Land division – realignment of allotment boundaries – two (2) into two (2).

**136 Valley Road, Montacute.**

DA 473/D001/15

<b>Application No</b>	473/D001/15
<b>Unique ID/KNET ID</b>	#13837831; 2015/03008/01.
<b>Applicant</b>	Susan Merret.
<b>Proposal</b>	Land division to realign allotment boundaries – two into two.
<b>Subject Land</b>	136 Valley Road, Montacute.
<b>Zone/Policy Area</b>	Watershed (Primary Production) Zone – Water Protection (Marble Hill) Policy Area.
<b>Relevant Authority</b>	State Commission Assessment Panel
<b>Lodgement Date</b>	10/01/2015
<b>Council</b>	Adelaide Hills Council.
<b>Development Plan</b>	Consolidated 09/01/2014.
<b>Type of Development</b>	Merit
<b>Public Notification</b>	Category 1
<b>Representations</b>	Not Applicable.
<b>Referral Agencies</b>	Department for Environment & Water (Native Vegetation Council), SA Country Fire Service, Department of Health, SA Water.
<b>Report Author</b>	Malcolm Govett, Planning Officer
<b>RECOMMENDATION</b>	Development Approval, with Land Division Consent, subject to conditions

**Figure 1: Proposed Land Division.**

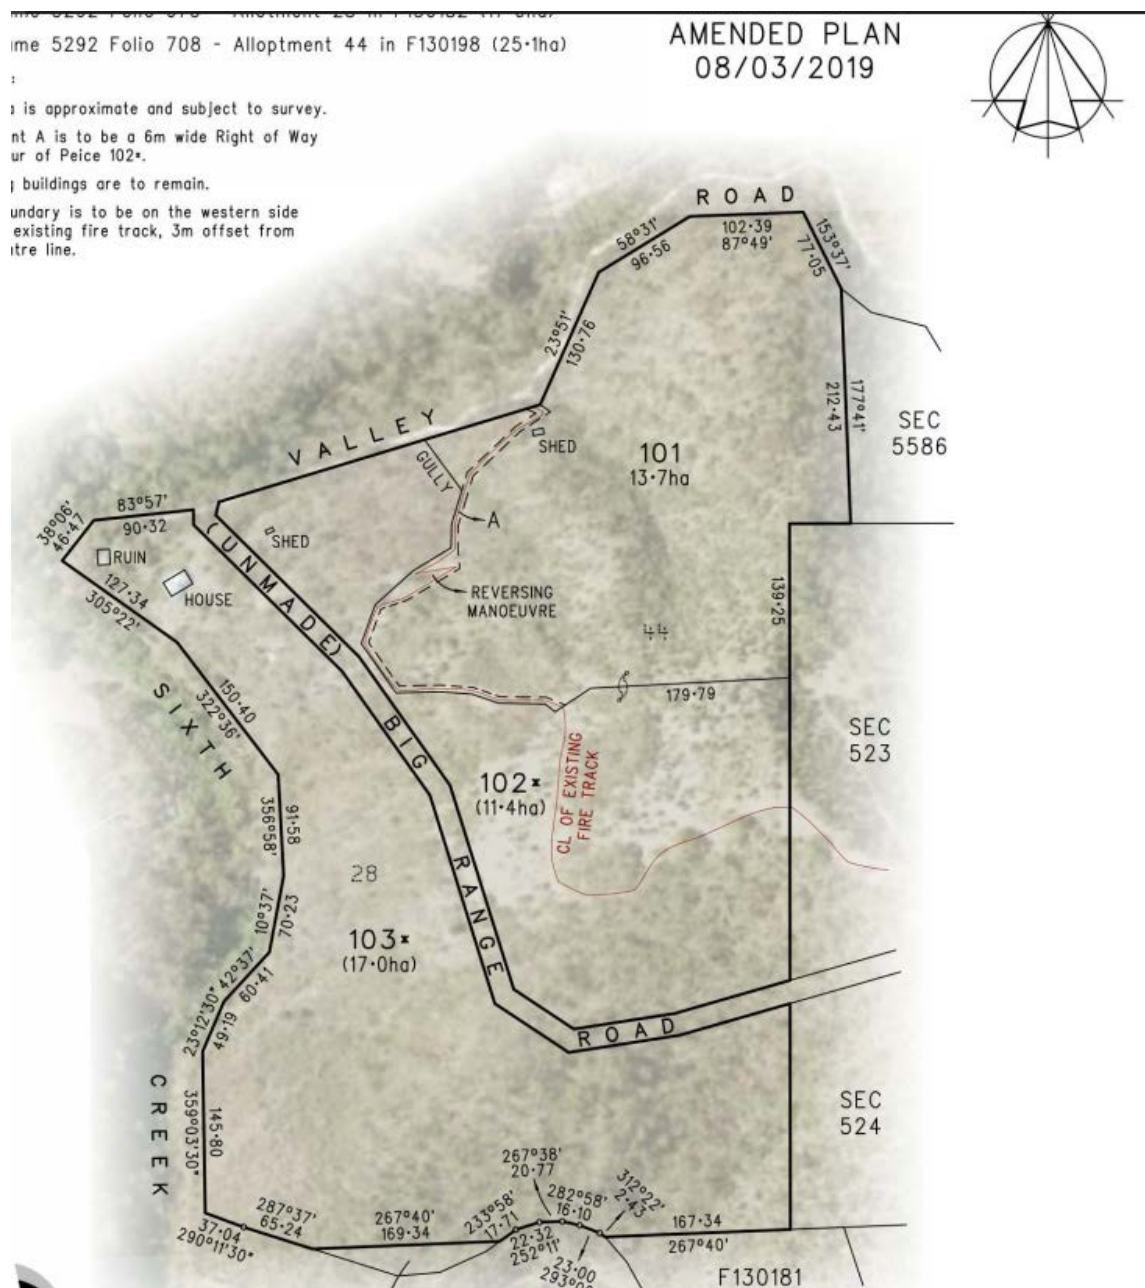
The Adelaide Hills Council indicates it does not support the proposed development because it is not considered to be a minor readjustment of boundaries as it would not correct an anomaly, and would not improve the management of the land for conservation or primary production purposes. The proposal would not represent an orderly form of development as one of the allotments would be separated by an unmade public road and would rely on a right of way for access for management. Also, the proposal would result in the creation of a part allotment over an area of native vegetation.

- It is inconsistent with Watershed (Primary Production) Zone Principle of Development Control 20 as it is not considered to be a minor readjustment of boundaries. The proposal does not correct an anomaly, and the readjustment will not improve management of the land for conservation or primary production purposes.
- It is inconsistent with Council Wide Objective 1 & Principle of Development Control 2 as the allotment arrangement comprising Pieces 102\* and 103\* separated by an unmade road is not an orderly form of development and relies on a right of way for access for management.
- It is inconsistent with Watershed (Primary Production) Zone Principles of Development Control 33 & 34 and Council Wide Objective 79 as it will result in a part allotment created over an area of native vegetation.

On balance, it is considered the application has sufficient merit to warrant support. It is considered the land division is consistent with the provisions of the Watershed (Primary Production) Zone because it would not create any additional allotments or opportunities for development, it would not significantly or adversely impact the quality of water resources, and it would not cause the loss of productive primary production land.

It is also considered the design of the proposal would minimise impacts on the natural features of the topography by reducing the need for excavation works and the removal of native vegetation cover.

# LAND DIVISION PROPOSAL PLAN

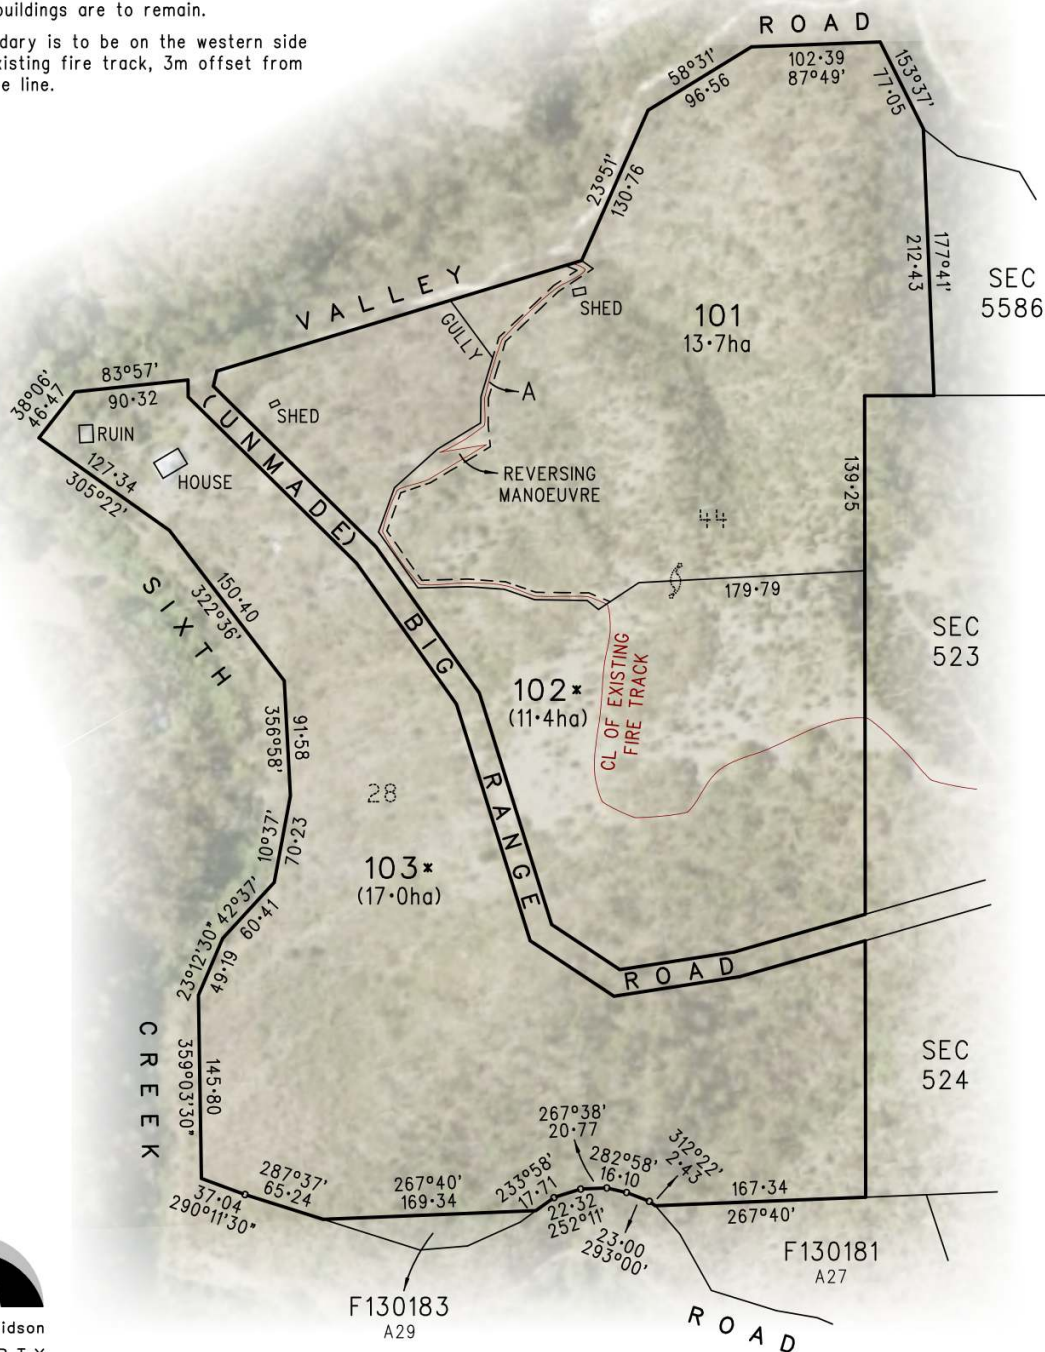
I attach the "Amended Plan 18-09-2018" – now only involving my client's 2 titles - C'sT 5292/675 F130182A28 and 5292/708 F130198A44.

The alteration to this plan is the removal of C'sT 5292/706 F130183 A29 and 5292/709 F130184 A30 thereby removing the technicality of trying to create the allotment 441 containing the ruin. My client chooses now to avoid this "stumbling block".

This plan now involves the alteration to the boundary between the 2 larger titles. The proposed boundary, as indicated and shown on the plan, intends to coincide with the western edge of an existing fire track linking through the property from Valley Rd along the north to Montacute Conservation Park adjoining the eastern boundary of the site.

The balance of the land comprises the Pieces 102\* & 103\* to form one allotment. It is intended for the Piece 102\* which adjoins the existing fire track to have a free and unrestricted right of way over it, labelled A on the plan.
